Bid Addendum No. 1

Pawling Central School District 2020 Capital Project – Phase 3

Pawling Elementary School: SED No. 13-12-01-04-0-001-024

CSArch Project No. 208-2101.03

Sheet No.
**PES
AD101**
CONSTRUCTION DOCUMENTS

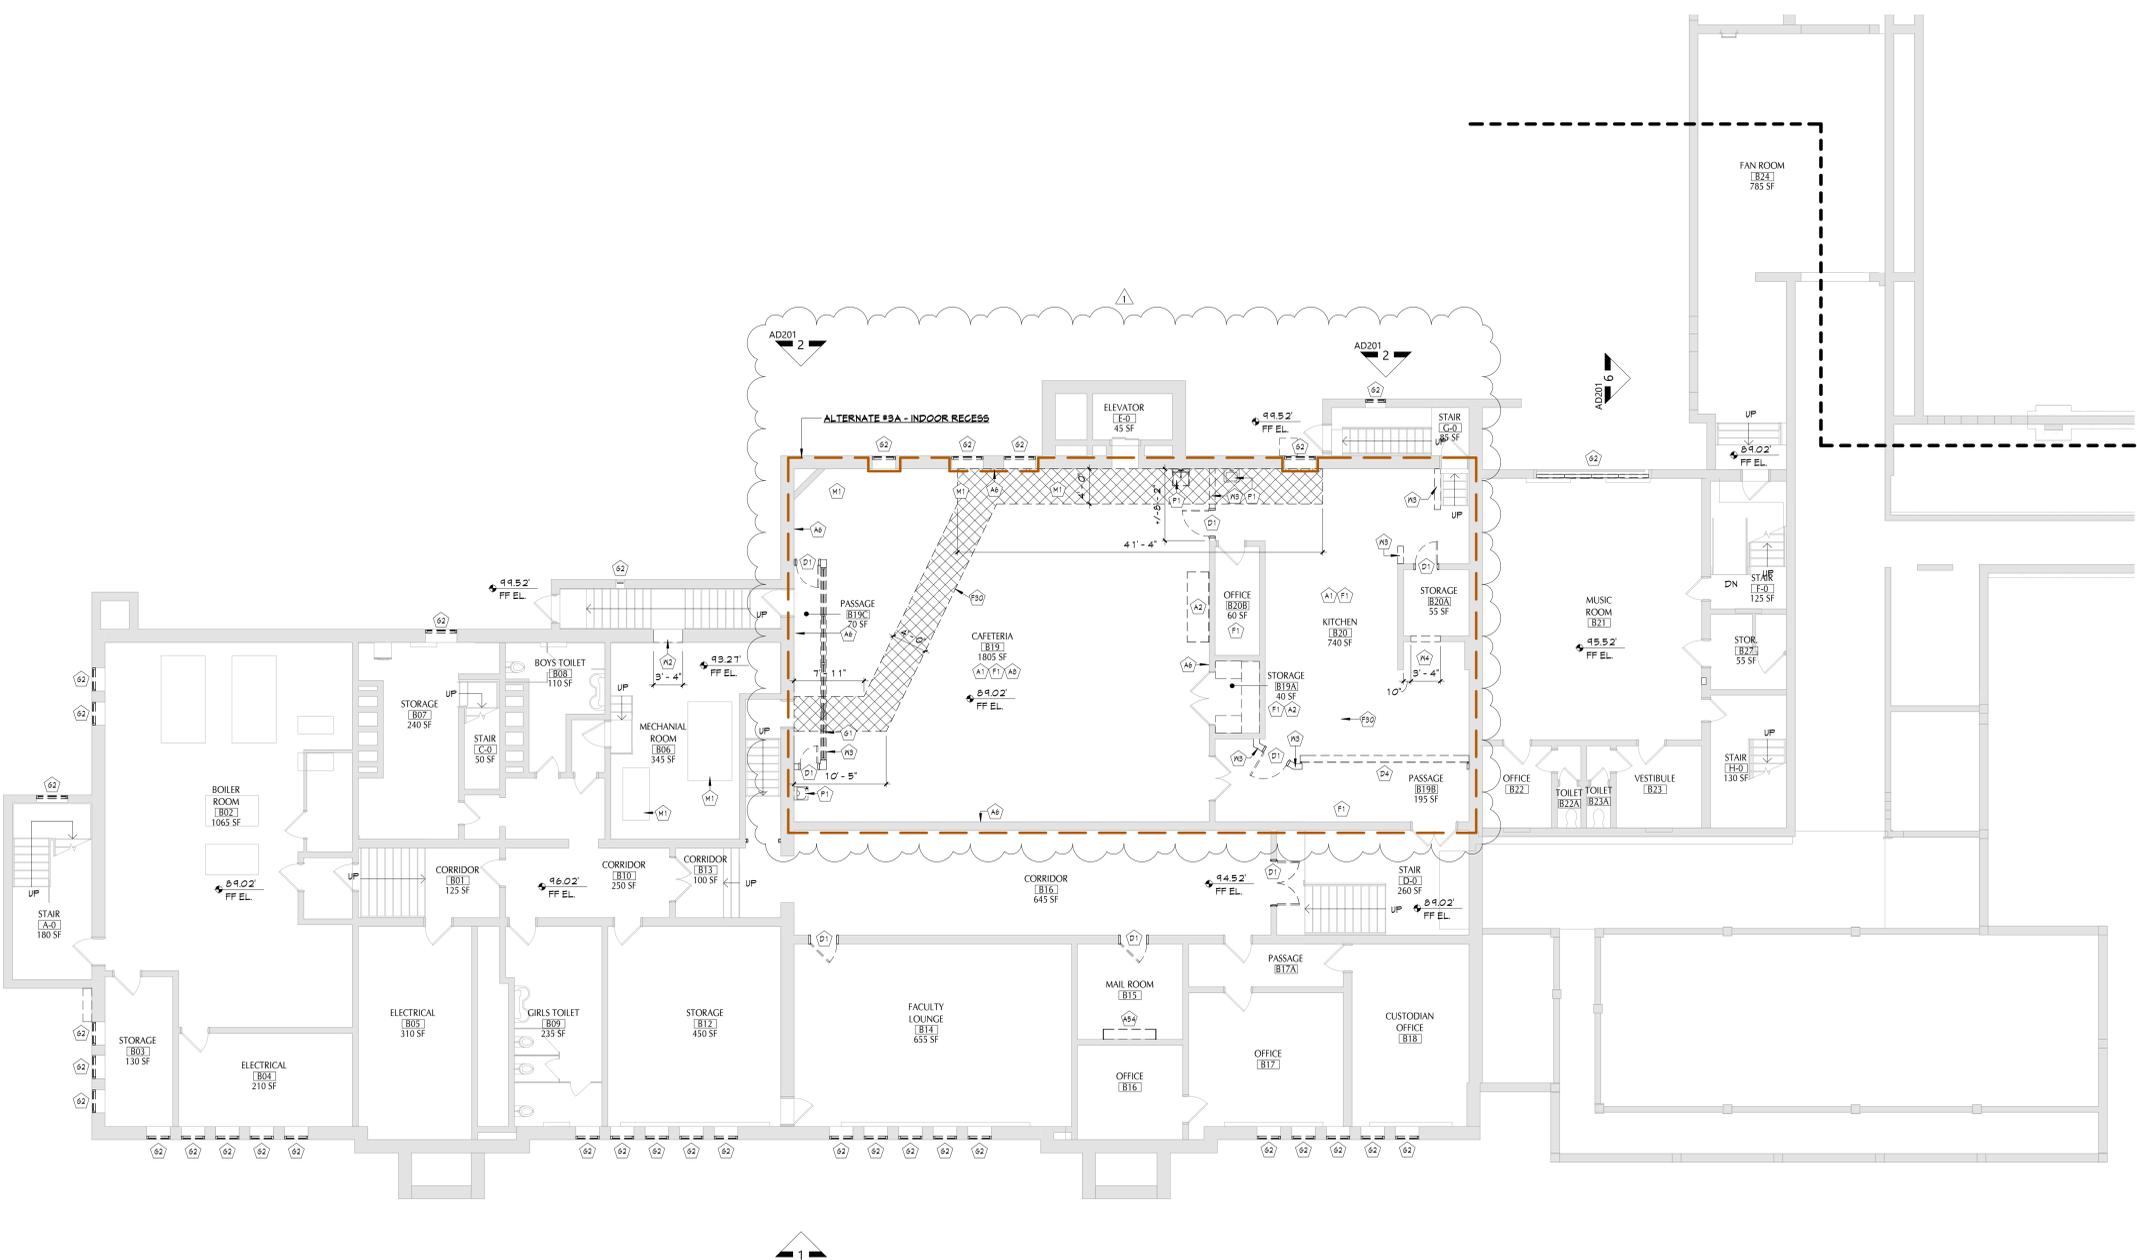
BASE-BID WINDOW VENT PANEL INFILL - Provide 1" insulated aluminum faced panels (white) fastened with L-clips and snap trim and sealed to the existing window system as Base-Bid. If the Window Alternates are approved the panel infills will not be required in that Area. Panel sizes listed are approximate and will need to be field verified by the Contractor prior to construction. (Existing room numbers indicated):

Area 1A
Library 149 (2) 20' x 36" panels at removed wall AC units.

Area 1C
Classroom 123 (1) 14' x 44" panel at removed grille, (1) 48" x 44" panel at removed wall AC unit.
Classroom 124 (1) 14' x 44" panel at removed grille, (1) 48" x 44" panel at removed wall AC unit.
Classroom 125 (1) 14' x 44" panel at removed grille, (1) 48" x 44" panel at removed wall AC unit.
Classroom 126 (1) 14' x 44" panel at removed grille.
Classroom 127 (1) 14' x 44" panel at removed grille, (1) 48" x 44" panel at removed wall AC unit.
Classroom 128 (1) 14' x 44" panel at removed grille, (1) 48" x 44" panel at removed wall AC unit.
Classroom 129 (1) 14' x 44" panel at removed grille, (1) 48" x 44" panel at removed wall AC unit.
Classroom 130 (1) 14' x 44" panel at removed grille.
Classroom 132 (1) 14' x 44" panel at removed grille, (1) 48" x 44" panel at removed wall AC unit.
Classroom 134 (1) 14' x 44" panel at removed grille.
Classroom 136 (1) 14' x 44" panel at removed grille.
Classroom 138 (2) 14' x 44" panels at removed grilles.

Area 1D
Kindergarten 101 (2) 14' x 44" panels at removed grilles.
Kindergarten 102 (2) 14' x 44" panels at removed grilles, (1) 48" x 44" panel at removed wall AC unit.
Kindergarten 103 (2) 14' x 44" panels at removed grilles.
Kindergarten 104 (2) 14' x 44" panels at removed grilles.
Classroom 113 (1) 14' x 44" panel at removed grille, (1) 48" x 44" panel at removed wall AC unit.
Classroom 114 (1) 14' x 44" panel at removed grille, (1) 48" x 44" panel at removed wall AC unit.
Classroom 115 (1) 14' x 44" panel at removed grille.
Classroom 116 (1) 14' x 44" panel at removed grille.
Classroom 117 (1) 14' x 44" panel at removed grille.
Classroom 118 (1) 14' x 44" panel at removed grille.
Classroom 119 (1) 14' x 44" panel at removed grille.
Classroom 120 (1) 14' x 44" panel at removed grille, (1) 48" x 44" panel at removed wall AC unit.
Classroom 121 (1) 14' x 44" panel at removed grille.
Classroom 122 (1) 14' x 44" panel at removed grille, (1) 48" x 44" panel at removed wall AC unit.
